Enersource Hydro Mississauga Inc.

**Application for electricity distribution rates and other
charges effective January 1, 2016.**

AMPCO's Final Submissions

Figure 1. Enersource’s actual and proposed capital investment portfolio expenditures (2011-2021)

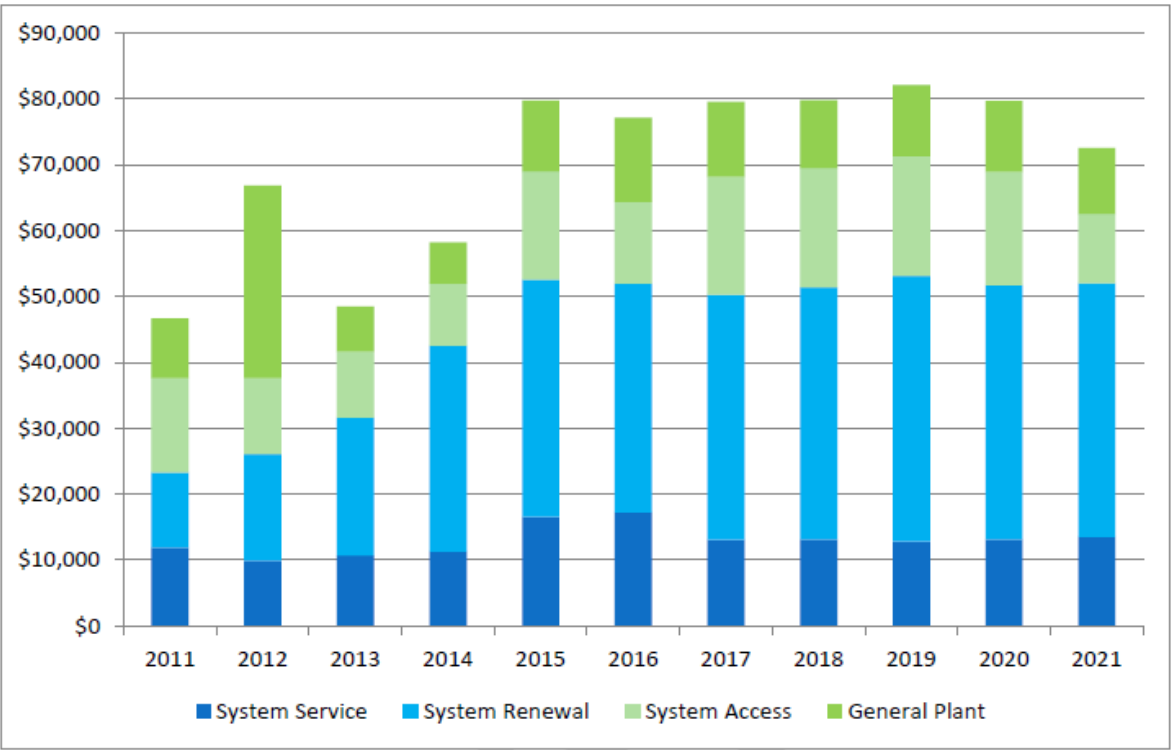
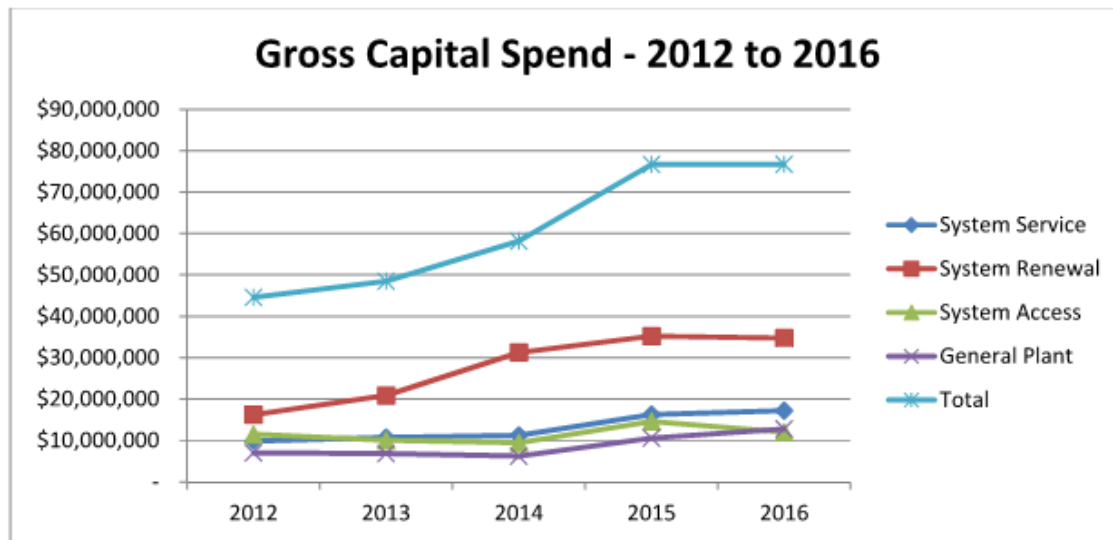
AMPCO's position is that Enersource has not adequately justified increasing its System Renewal spend by 60% over 2013 actuals, from \$46.173 to \$74.572. In AMPCO's view, Enersource's 2016 proposed asset renewal capital spend is at a pace and scope that exceeds the results of its most recent 2014 Asset Condition Assessment (ACA)⁸ which was used to develop the 2016 budget.
